MEMORANDUM

Re: PB 87-56 Monteray Shores, Phase 10 – Corolla Boat Club – 2nd Review
Amended Sketch Plan/Special Use Permit
Marina Special Use Permit

AMENDED SKETCH PLANS FOR COROLLA BOAT CLUB

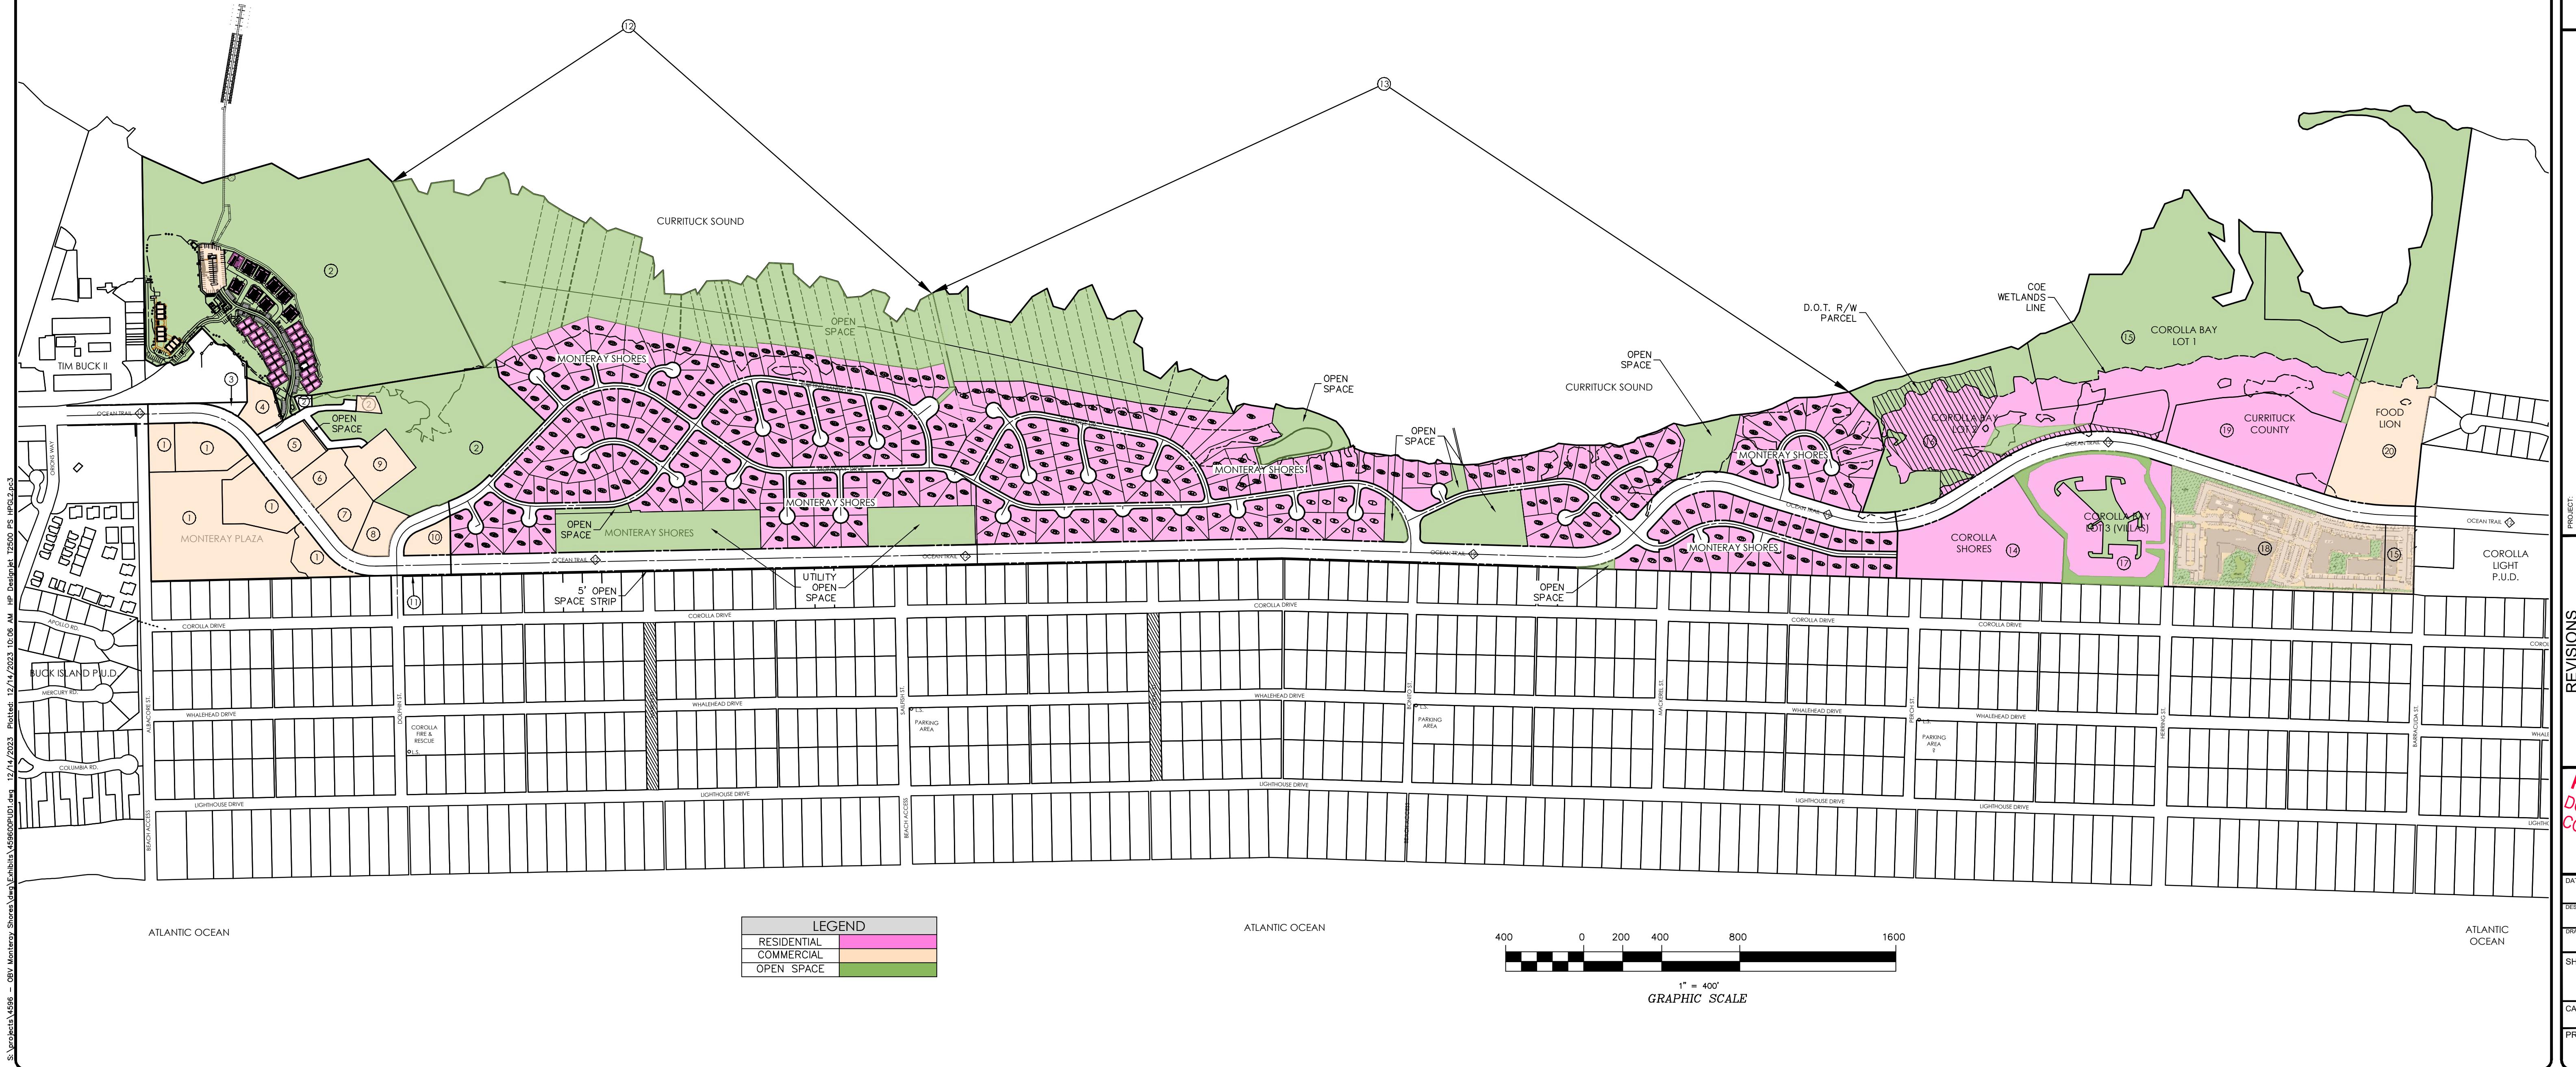
- 2 Please provide the overall amended sketch plan exhibit including the new proposed development. **An updated overall PUD sketch plan has been added.**

MIXED USE DEVELOPMENT LAYOUT & CONCEPTUAL PLAN

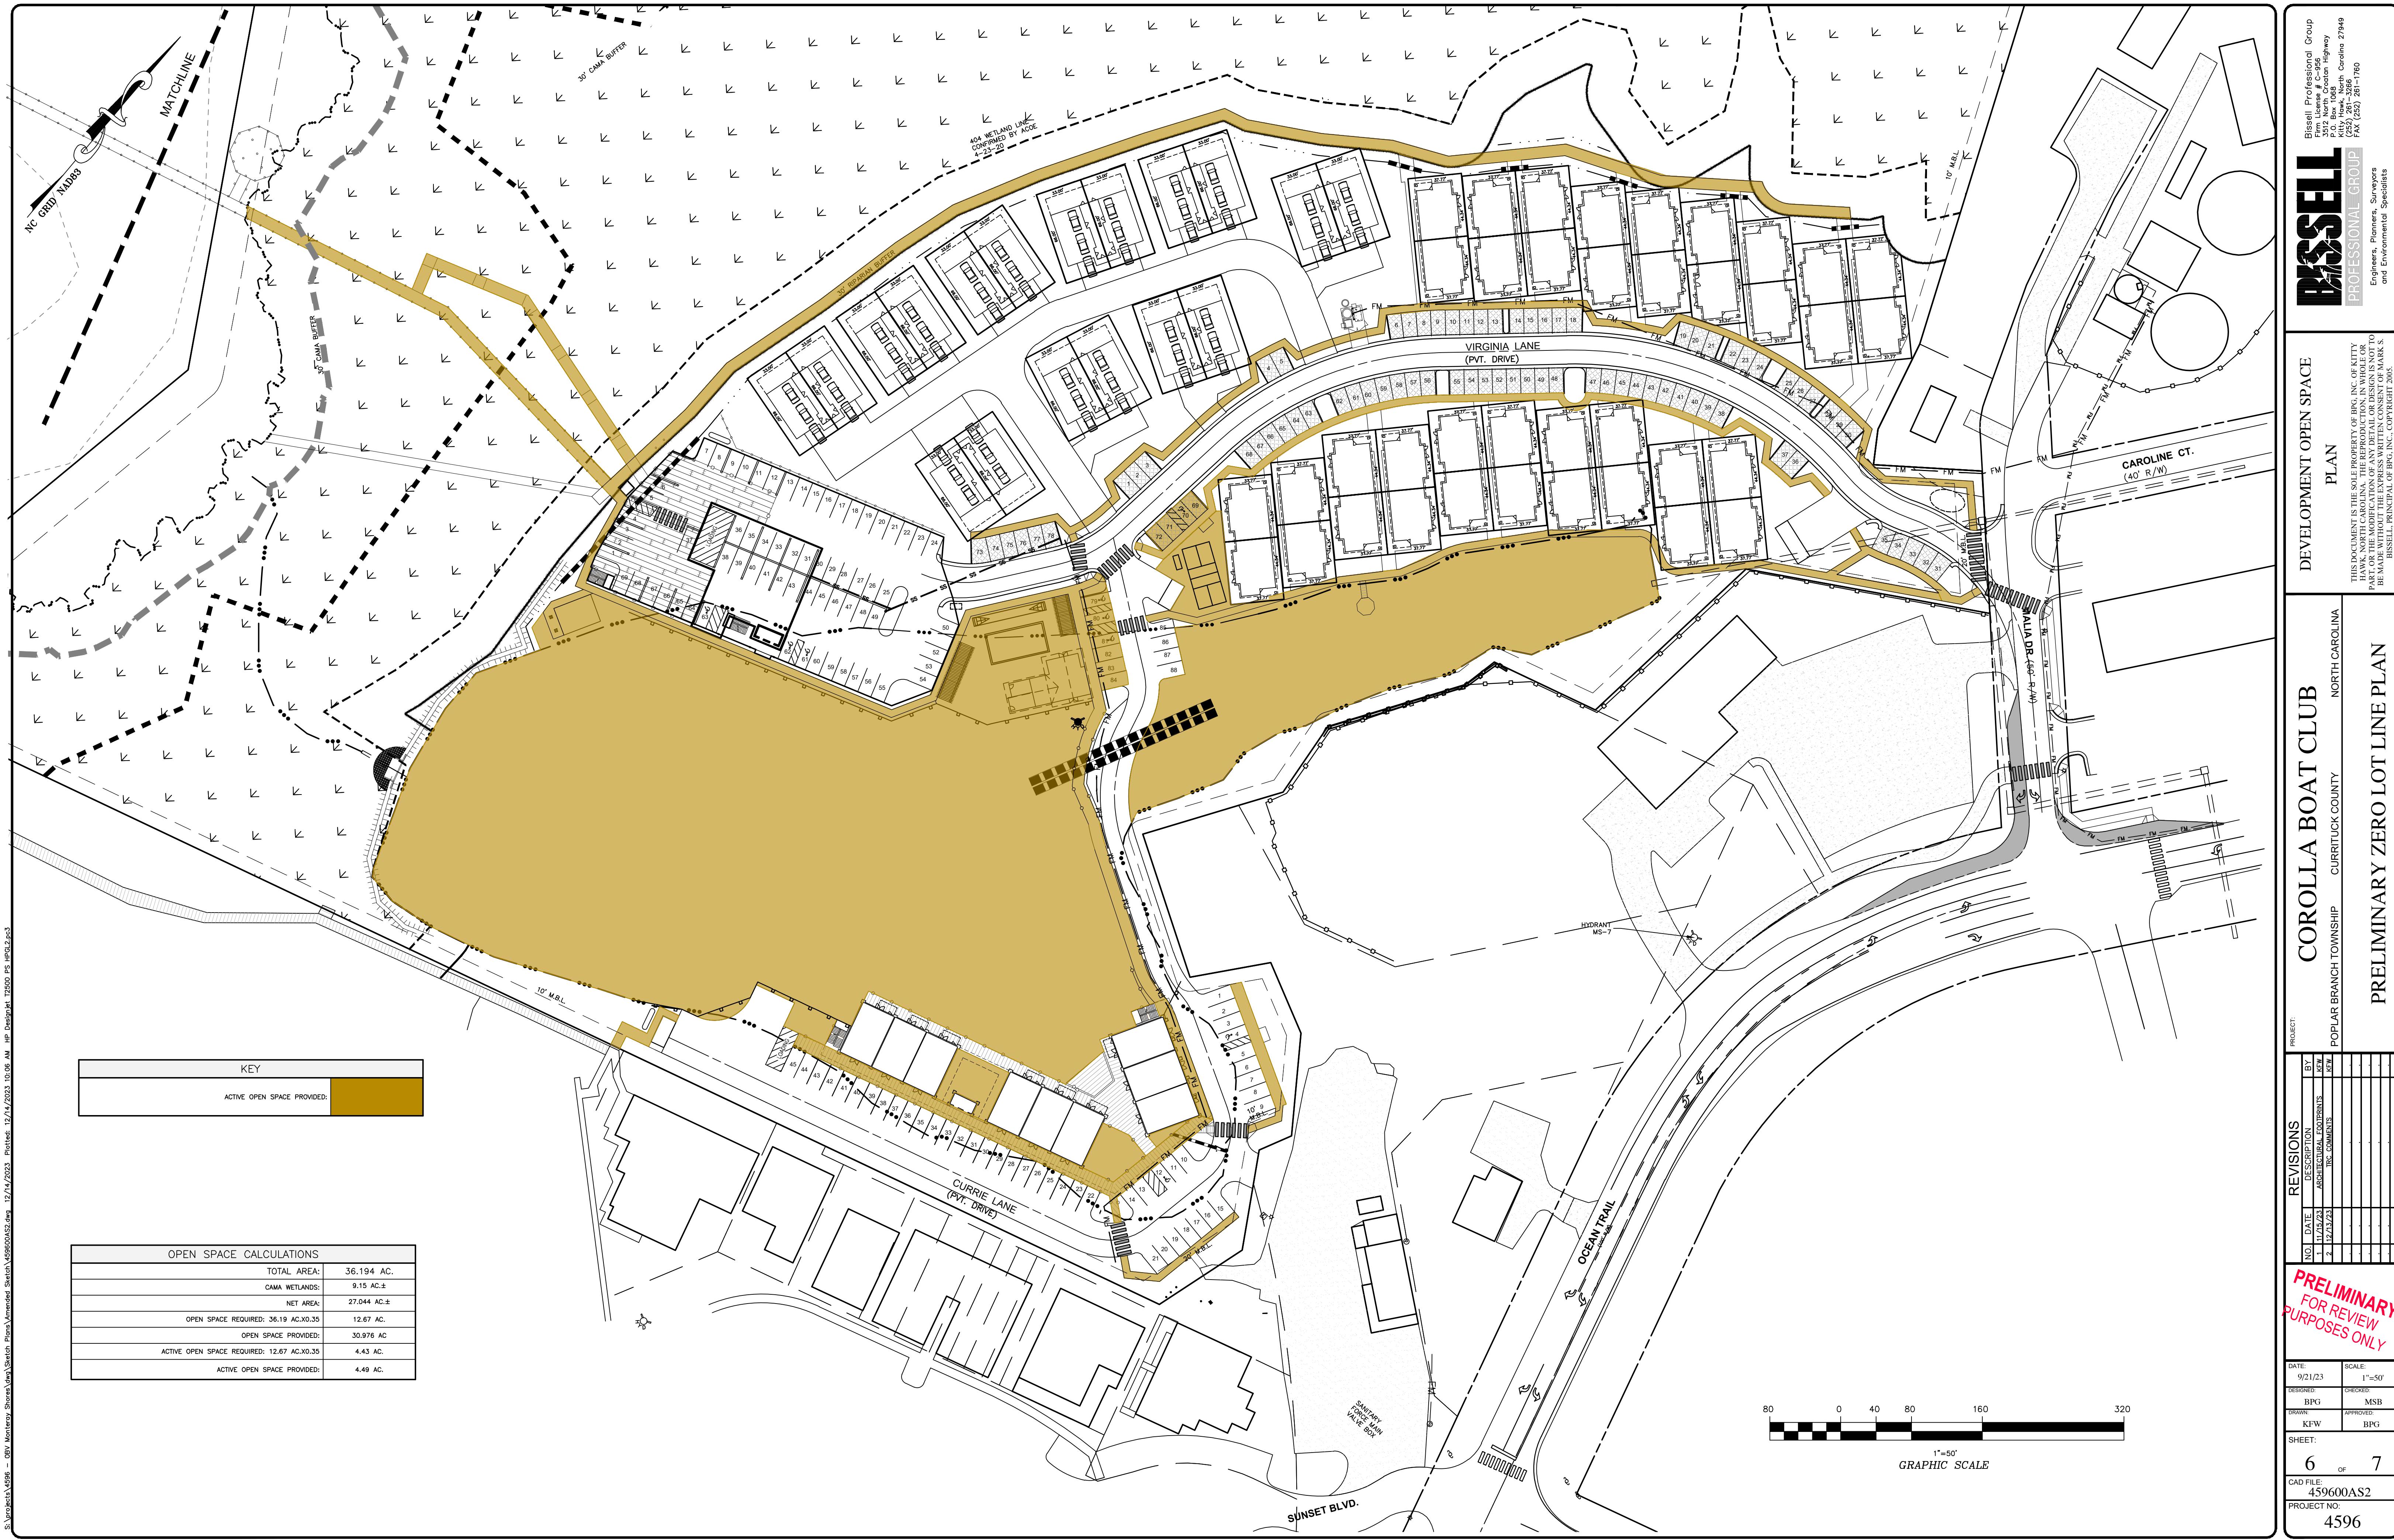
- 6 Driveways must extend 20' into the property before establishing drive aisles or parking spaces. **The encroaching parking space was removed; additional feedback is needed on the Currie Lane location.**

- 10 Please label Virginia Lane and Currie Lane as private driveways. **The labels have been added.**

The turnaround space at the end of Currie Lane is inadequate to accommodate the turning radius of fire apparatus, especially during business hours when the loading zone will be occupied. The turning space is long enough to accommodate an ambulance but not wide enough, especially if the loading zone is occupied. Suggest elongating the west end of the turnaround and the bulkheaded area to 30 feet each and widening the bulkheaded area to one and a half the current width. The bulkheaded area will need to be able to carry the load of the heaviest apparatus which is close to 80,000 pounds. **The width has been increased to 30' in both directions.**

There is no turnaround space at the end of Virginia Lane to accommodate ambulances and fire apparatus in the restaurant parking lot. Exiting the parking lot will require vehicles to back down the roadway on Virginia Drive to the Currie Drive intersection. Suggest revising the parking lot layout to provide space that allows turning around on the east end of the lot by the existing island. **The parking lot has been designed to provide an adequate turning radius.**

The fire hydrant on Virginia Lane is very close to R37. Suggest moving the fire hydrant to the island across the street near R32. **The hydrant has been relocated, but kept on the same side of the street to avoid a sewer conflict.**

1 North Elevation
A403 1/8" = 1'-0"

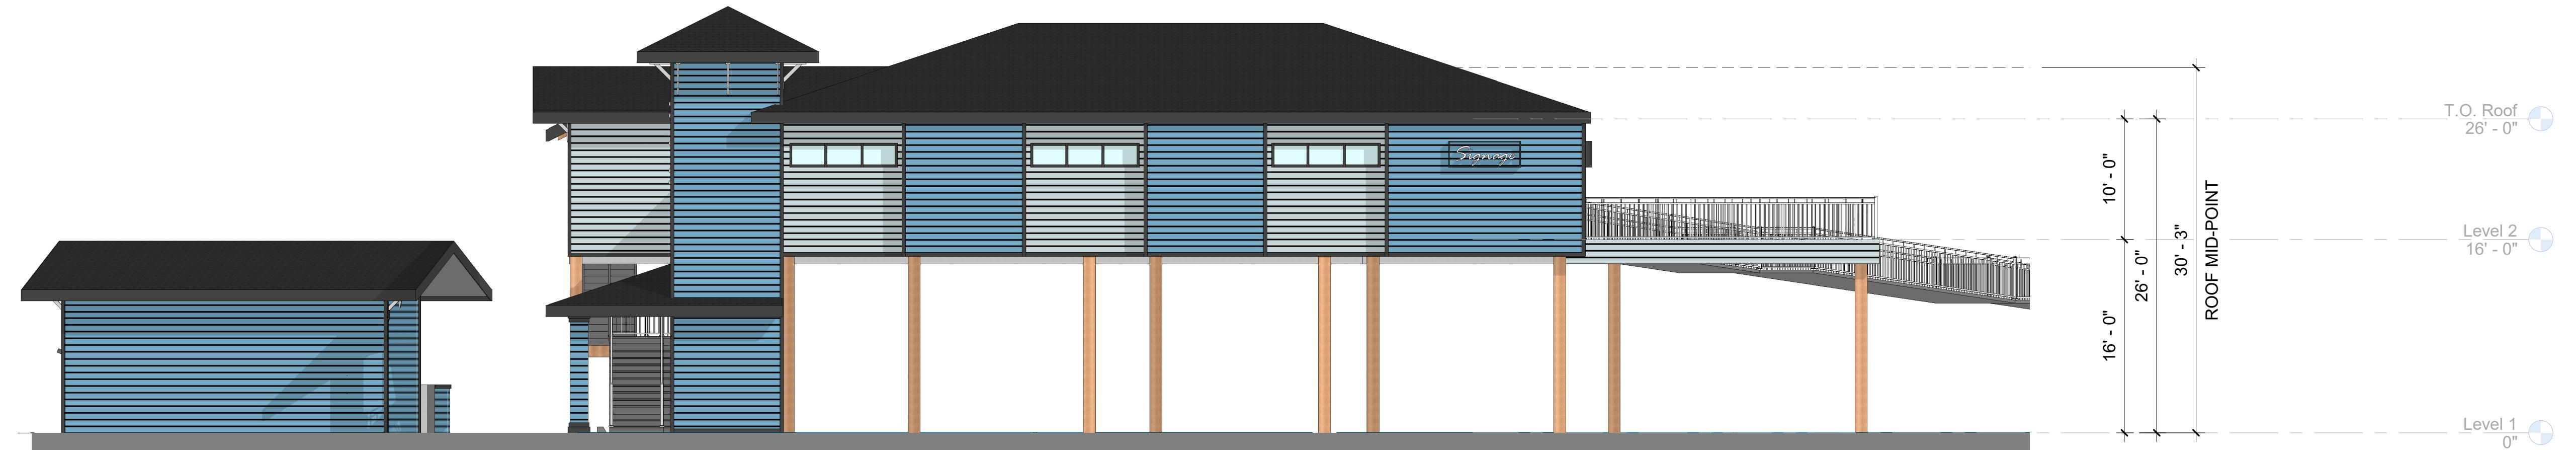
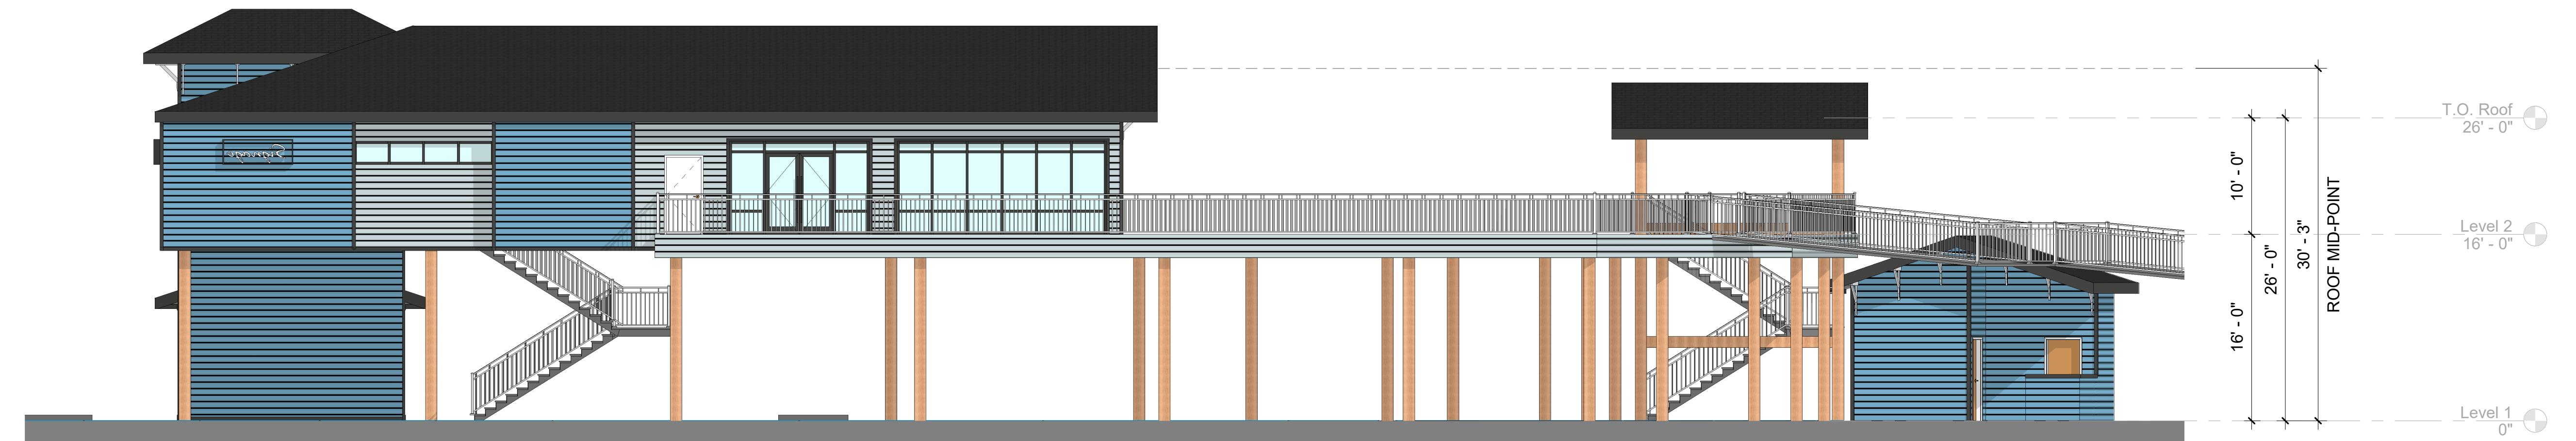
2. Non-residential design standards of UDO Section 5.8 apply to the restaurant building. Please describe how the proposed renderings meet these standards. **The Architect's building design uses projections and recesses in the building façade wall with a depth of 18" minimum from the façade plane with a minimum width of 10 feet; the façade color changes which follows the same dimensional standards as the offset standards; incorporation of roofline changes throughout design (i.e. elevator tower, exterior stairs, restaurant building); pitched roofs have eaves that exceed minimum of 12 inches from the building face; fenestration includes windows that are visible from adjacent streets; outbuilding (public restrooms on ground level) maintain a consistent level of architectural detail, materials and colors on all sides that are compatible with the primary building; and metal siding and/or overly bright, neon, or day-glow colors are NOT being used as the primary exterior building color).**
